August 5, 2016

Re: Arborist Review Tree Permit #2016-ARP-0023, Review and Recommendations
Site: Brentwood Beach LLC property, 17114 Brentwood PL NE, Lake Forest Park, WA 98155

Figure 1: Tree Protection Fence Drawing.

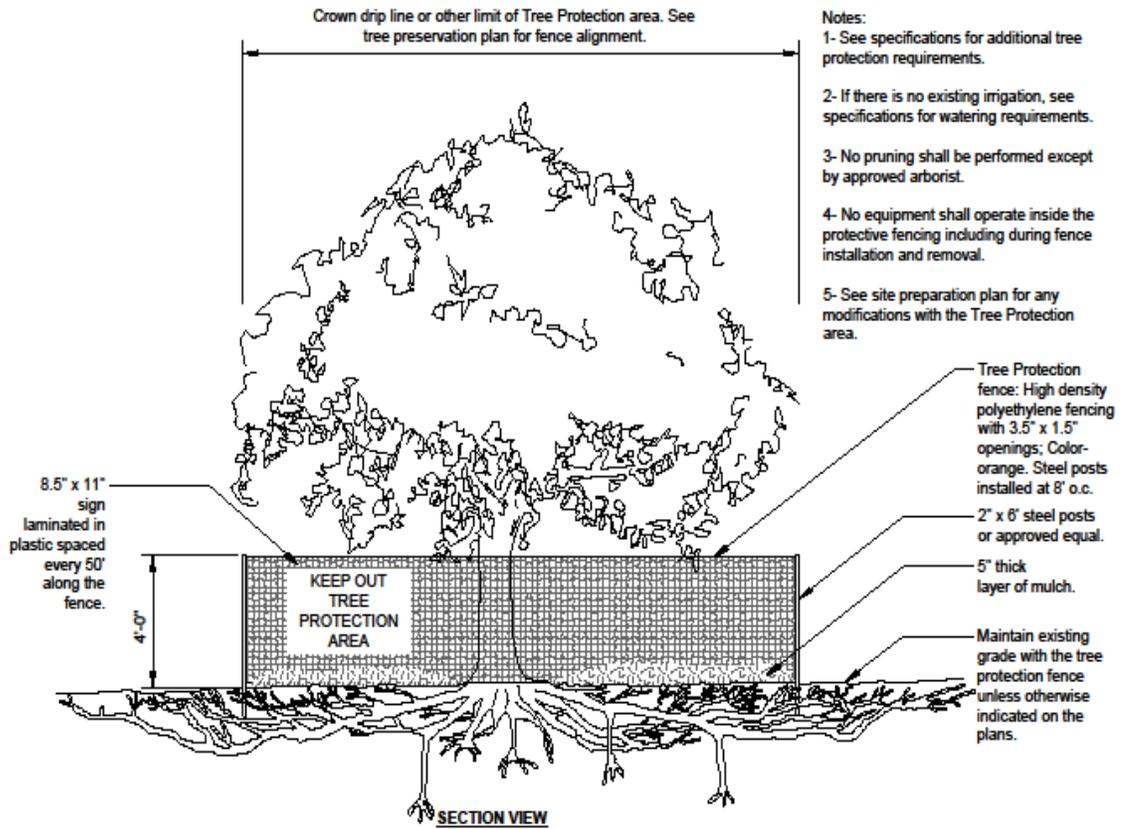
Refer to Figure :1 Tree Protection Fence Diagram.

1. Install a continuous circular TPF, of polyethylene laminar safety fencing material, a minimum of 4 feet high and supported by metal fence posts, spaced approximately 4 feet apart, in a radial arc 12 feet from the trunk of each the tree. Installation of the TPF facing the construction zone shall be as close to the edge of work as feasible, if less than the recommended 12 feet. Grading immediate to these areas should be limited as much as feasible.
2. Place a layer of mulch, woodchips are recommended, at least 4" in depth covering the area within the TPF.
3. The area within the tree protection fencing is the Tree Protection Zone (TPZ) and nothing must be parked or stored within the TPZ; no equipment, vehicles, soil, debris, or construction supplies of any sorts.
4. The TPF is to remain and be maintained for the entire time of the project.

1. Starting at the NW corner of the lot install a continuous TPF, of polyethylene laminar safety fencing material, a minimum of 4 feet high and supported by metal fence posts spaced approximately 4 feet apart, in a continues line in front of Trees 10, 11, 16, 18 and 20 at a distance equal to the drip line of each tree. Installation of the TPF facing the construction zone shall be as close to the edge of work as feasible, if less than the recommended extent of the drip line. Grading immediate to these areas should be limited as much as feasible.

The Tree Protection Fences need to be clearly marked with the following or similar text in four inch or larger letters:
